DMG-240924

Addendum to main acoustic report for the land off Princedom St, Manchester.

This short addendum is in response to queries from Environmental Protection regarding our main report, ref DMG-240924, dated 26th September 2024. The text of the queries is copied in the Appendix below.

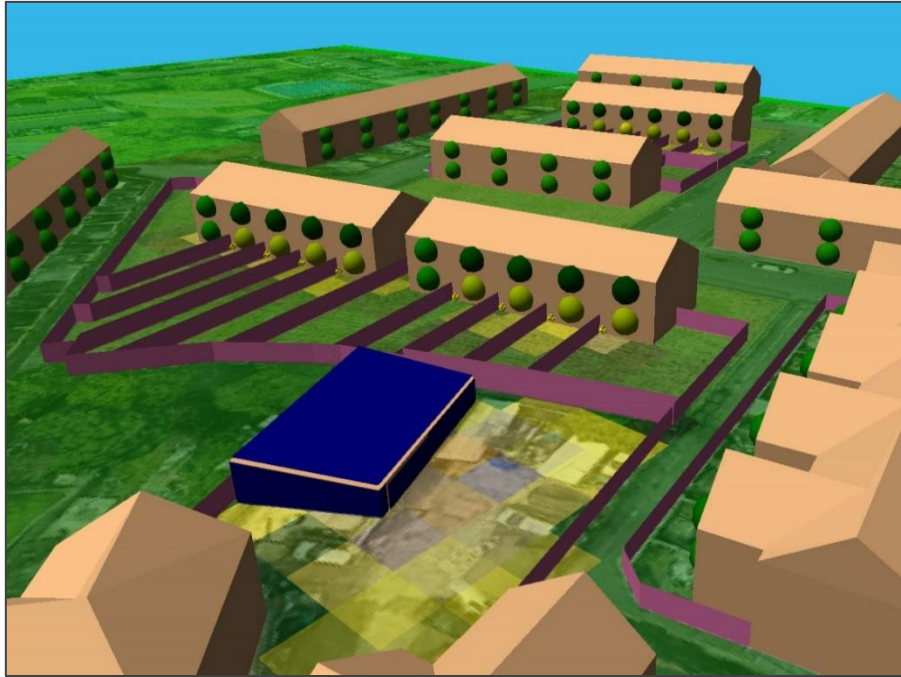
5. The report states that "*There was also occasional engine revving from what appeared to be a car dealers and garage to the southeast*" and makes no further consideration of this potential noise source and possible impacts on future occupants of the development site. The approach proposed by Rob Smith was to try to obtain measurements of noise emissions from this site to enable a reasonable assessment to be made and, in the absence of such measurements, reference data were to be utilised. The limited measurements obtained from monitoring positions located to the north of Princedom Street, stated to include the occasional engine revving from the site to the south east of the parcel of land to the south of Princedom Street, do not allow a reasonable assessment to be made of any potential impacts to future occupants of proposed dwelling units immediately adjacent to the garage site, and no reference data have been considered.

have been obtained by the applicant or their consultants and considered as part of the noise assessment. If a vehicle repair garage is the permitted use of the site, and measurement data representative of fully operational and potentially noise-making activities at the site cannot currently be obtained, then utilising reference data would be the most appropriate method to make a reasonable evaluation of potential noise emissions from the site.

The work was carried out on a similar site in West Yorkshire. Full details can be found on the Kirklees Planning Portal, reference 2021/92795. Individual activities were measured outside the open roller shutter doors. The building was then modelled with the open doors represented as vertical area sources and then adjusted to match the measured levels exactly. This gave us a calibrated sound power level per square meter. On that project we reproduced this source on the proposed new buildings in order to calculate their impact. The same is done here where a large (5.7m x 1.9m) open door is assumed on the eastern side of the building, the rest of the building shell being poor quality corrugated metal, with the same sound power per square meter distributed over all internal surfaces.

The following image shows a 3D view of the garage to assist with visualising how things fit together.
